ADDENDUM NO. 9

FINANCIAL ITEM NUMBER: 415474-2-52-01, 415474-2-52-02, and 415474-2-56-01
CONTRACT NUMBER: E3U76
DESCRIPTION: Design Build for SR 30 (US 98) Brooks Bridge No. 570034

Attached for your use is a redline revision to the RFP document previously distributed. The following is a summary of the revisions:

Figure 3: Lighting Design and Construction – West of Bridges

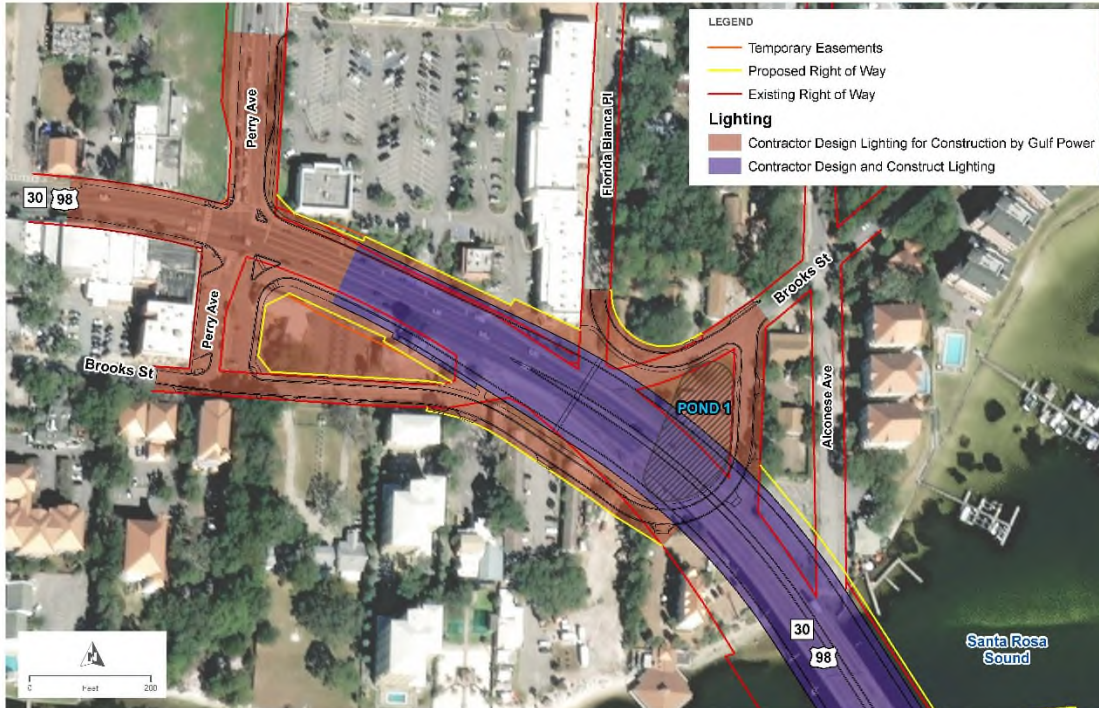
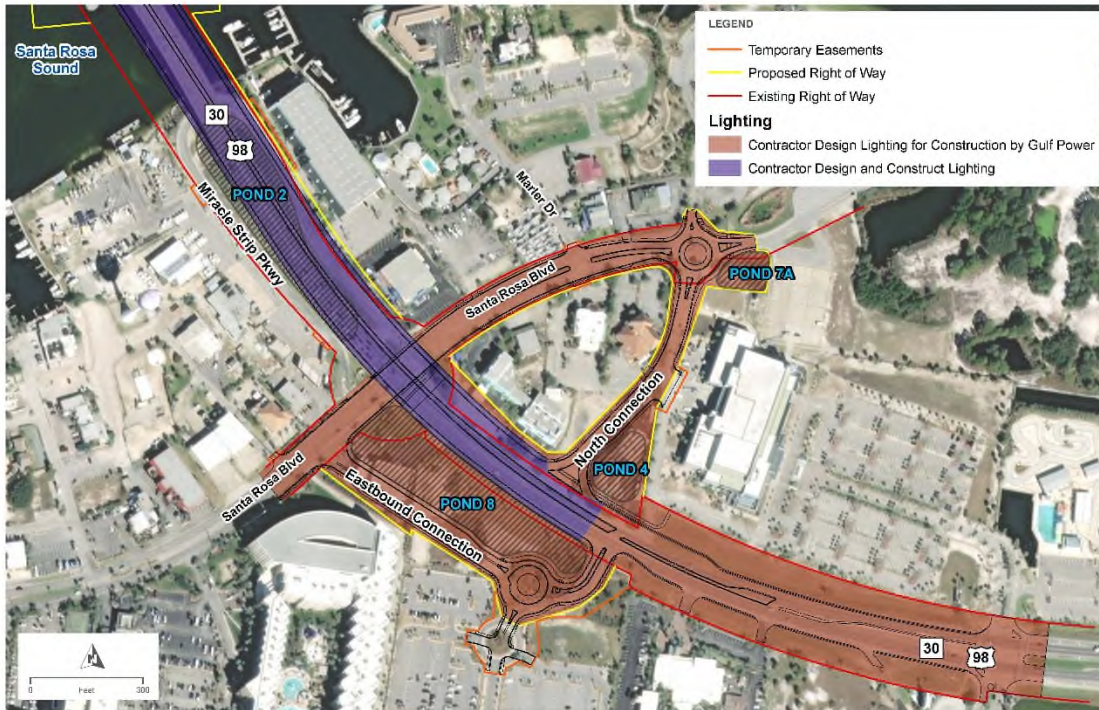
The proposed lighting is to be **typical** FDOT Conventional Lighting of the Light Emitting Diode (LED) type with full cutoff distribution to reduce sky glow as much as possible. High mast lighting is not allowed on this project.

The existing lighting in conflict with the proposed design shall be removed. **Temporary lighting shall be provided if existing lighting is removed prior to installation of proposed lighting.** The Design-Build Firm shall remove lighting in conflict and stockpile on site for the Department's contamination contractor to remove from the project. Contact the District Contamination Coordinator at (850) 330-1511.
